# Parcels 14 & 15 CV Properties Proposal Design Review Feedback

I-195 Redevelopment District Commission Meeting  
May 17, 2023

# Podium Plaza & Park Relationship

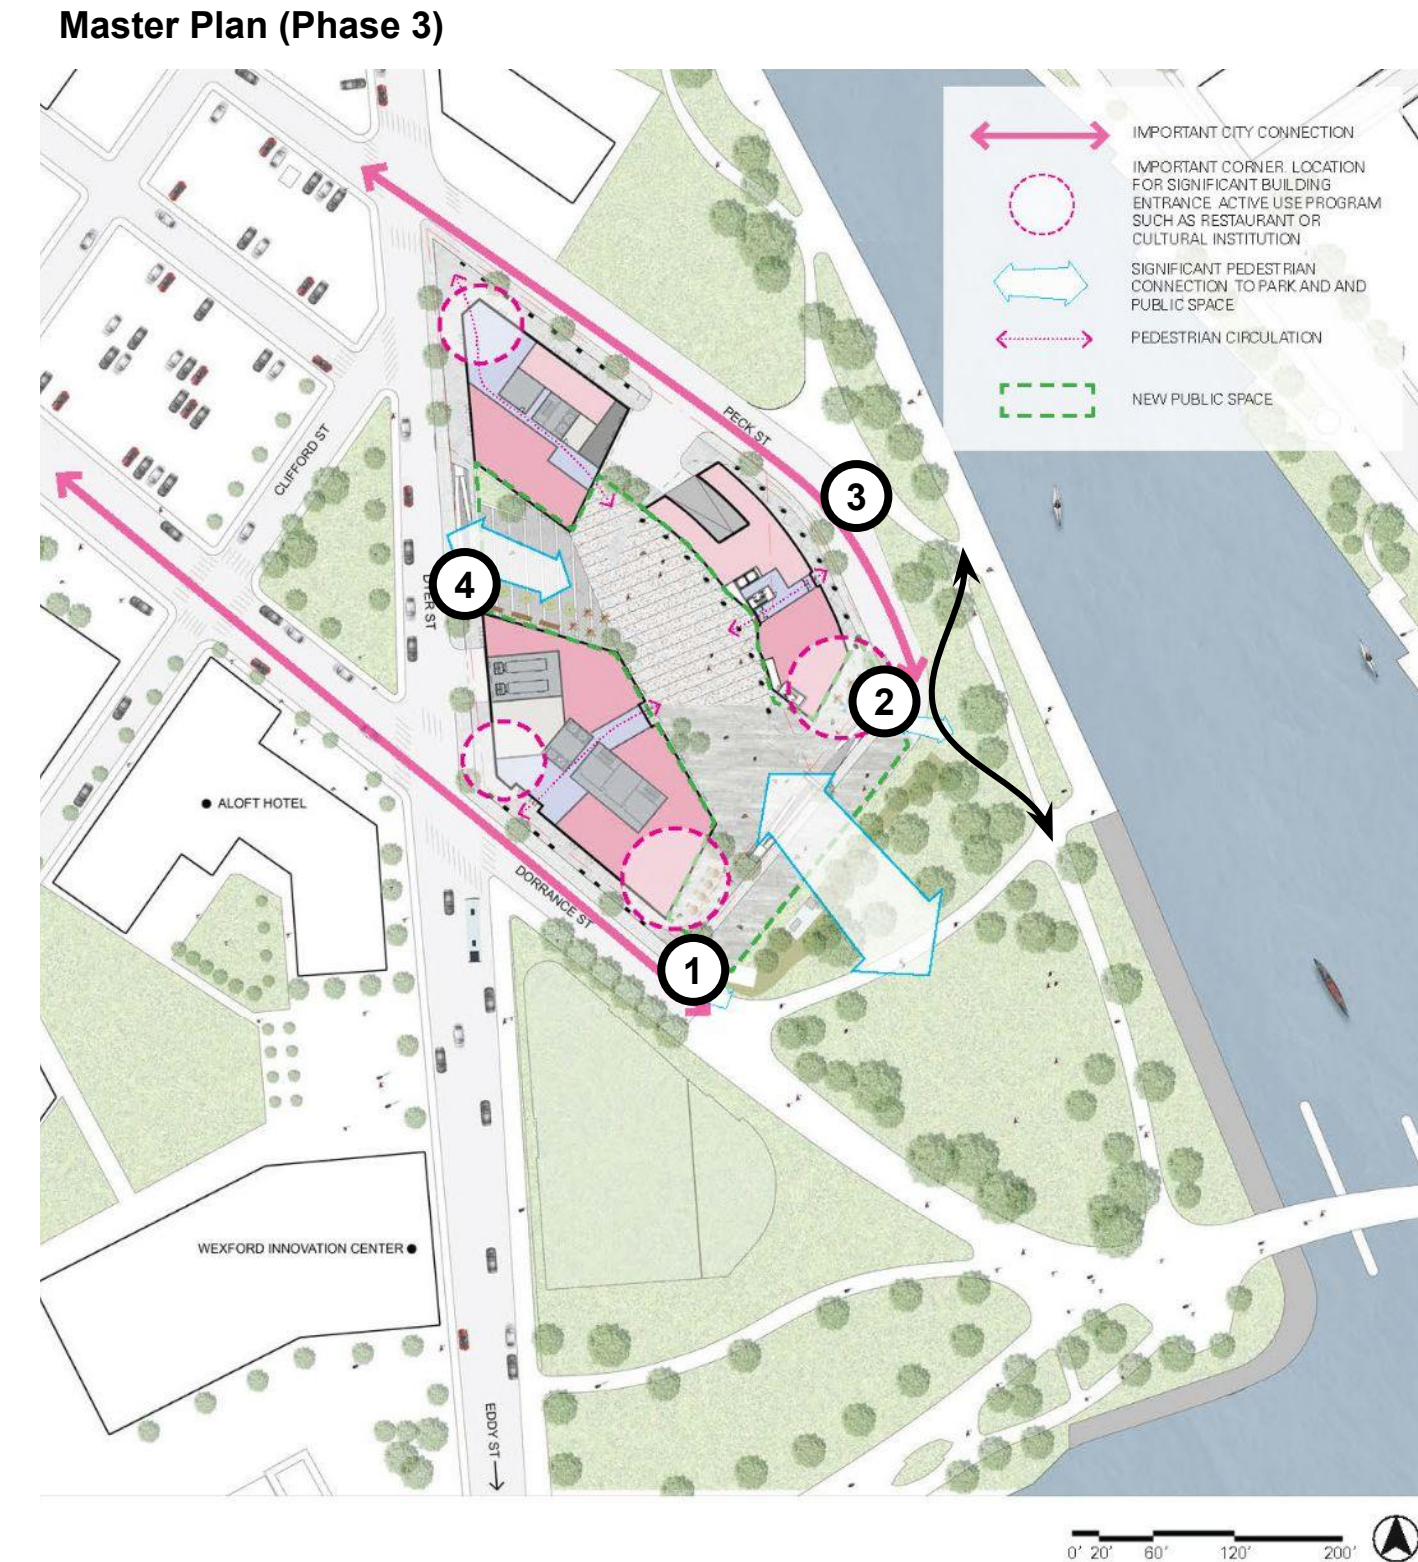
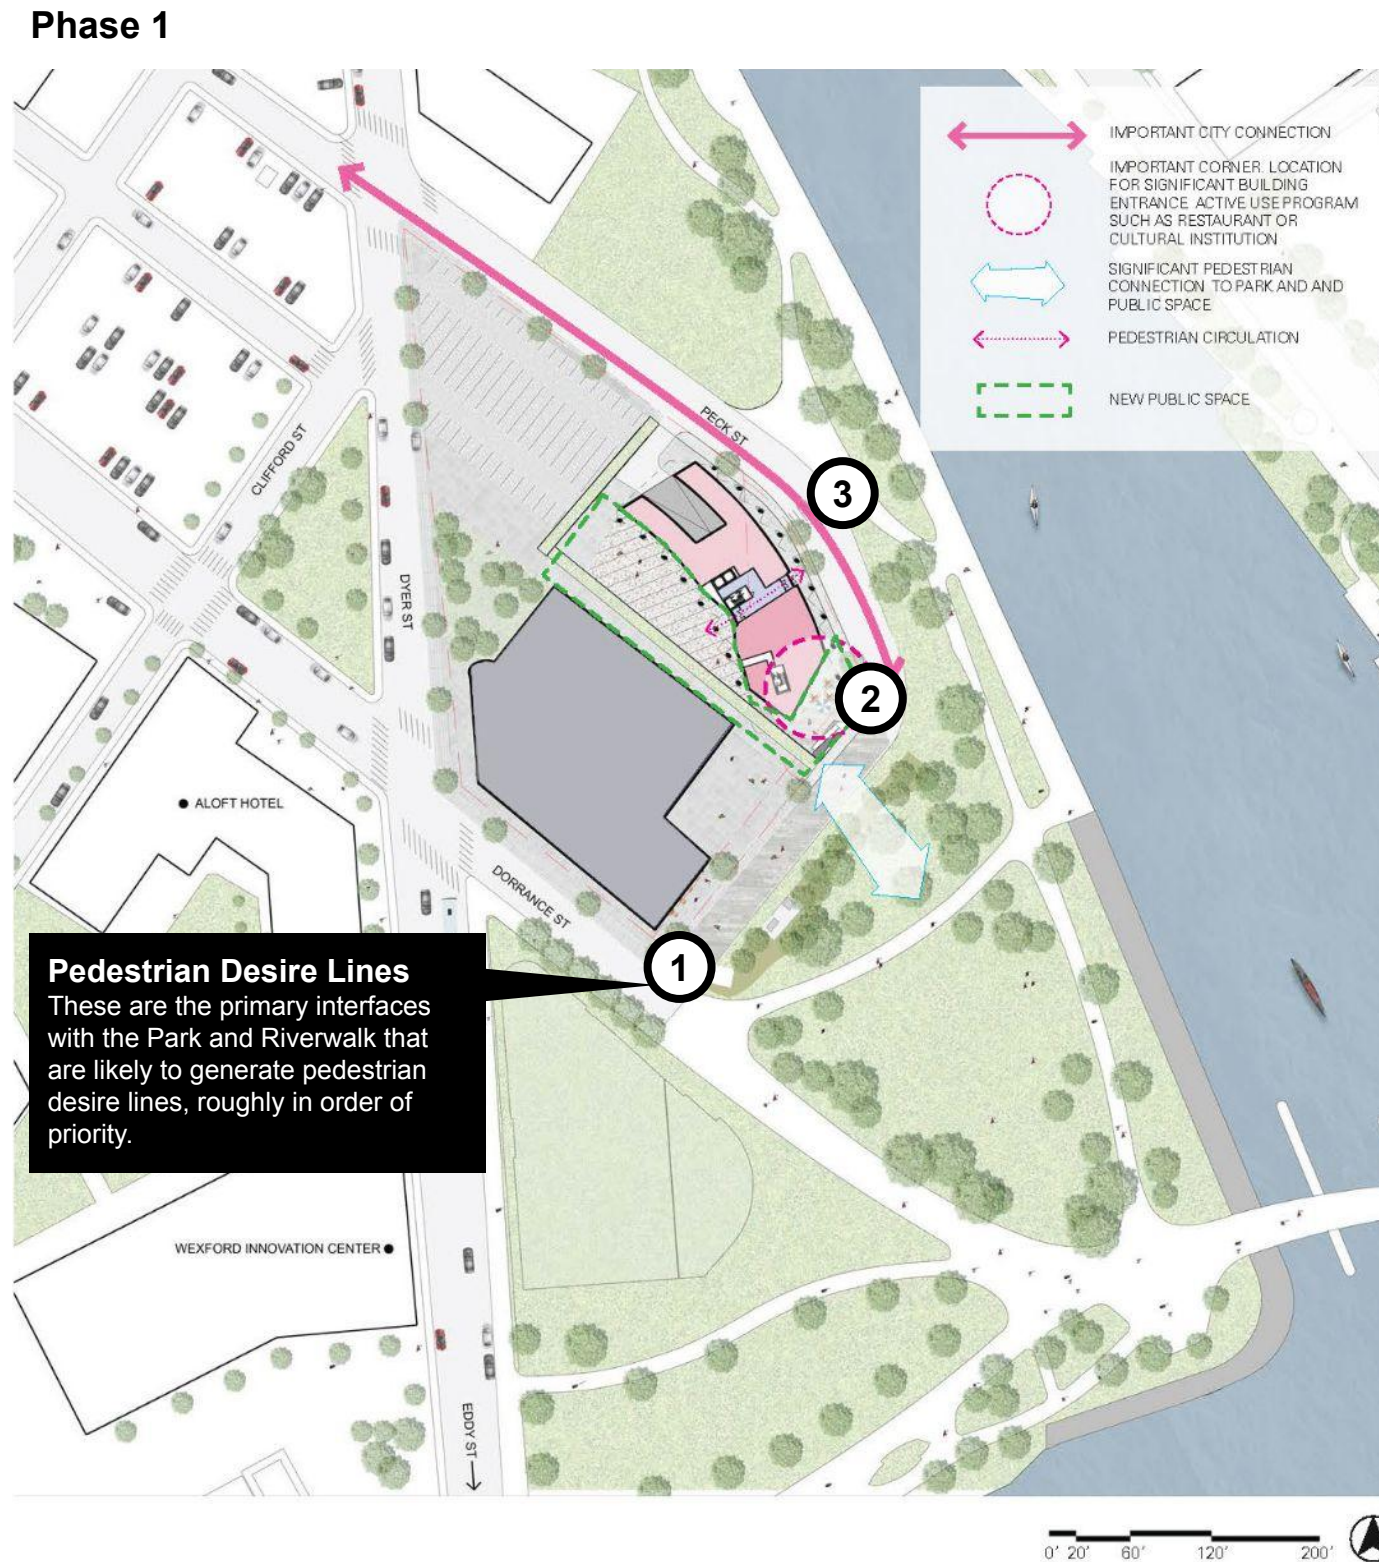
There are opportunities to further refine the relationship with Innovation District Park and the Riverwalk

- The function, design, and programmatic activation of the podium plaza must be balanced with the importance of the Dorrance Street frontage for continuity with Downtown, and with the importance of reinforcing the Park as the primary gathering place for the District.
- In addition to the programmatic activation, the design of the four key pedestrian entry points to the development must be given extra consideration to create a successful, mutually beneficial relationship with the park, riverwalk and public realm.
- The extent of the “Woonerf” shared street treatment of Peck Street should be studied further to confirm alignment with where the greatest pedestrian use will be concentrated.

# Building Scale, Massing & Materiality

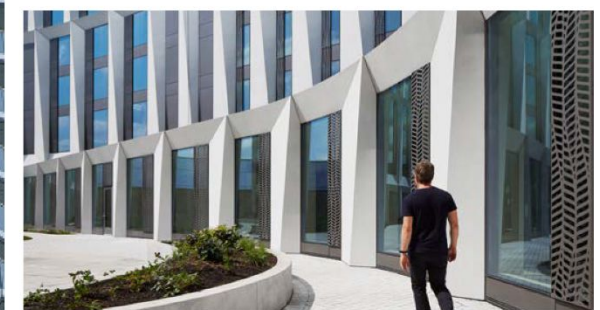
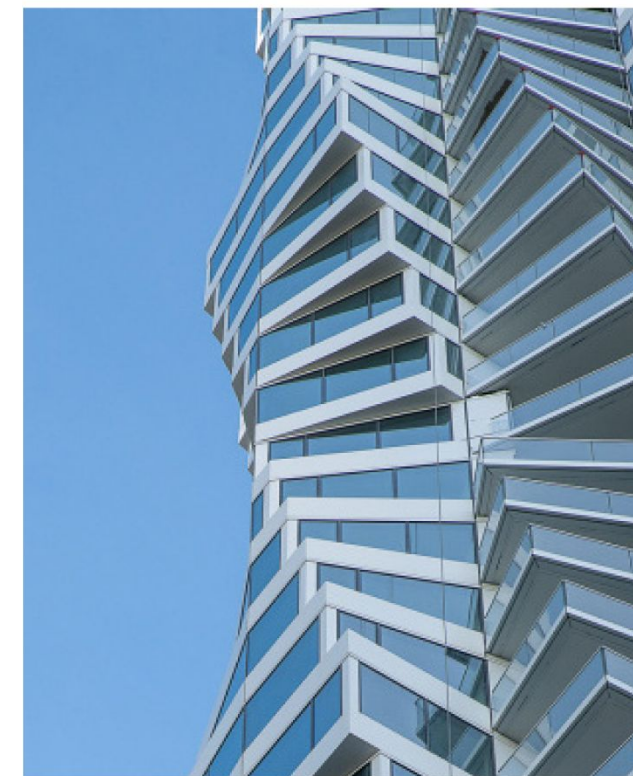
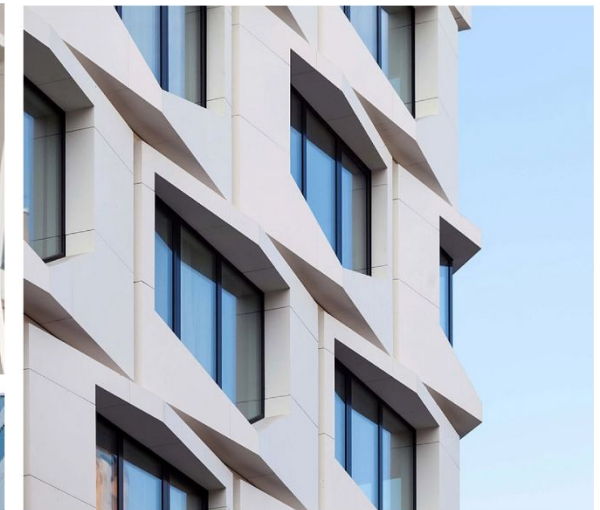
- Scale is consistent with the Development Plan and RFP, which require a minimum of 3 stories and a maximum height of 130' (which translates roughly to 11 stories, which matches this proposal)
- Unified sculptural move to pull into the park is strong. The comparatively simple, unified materiality makes the sculptural massing move more effective.
- Differentiation of the top floor would help to provide a more varied and engaging facade from the river, and would help break down the otherwise relatively monolithic approach to the river-facing facade.
- Appreciate that a variety of architectural styles are shown for the Master Plan
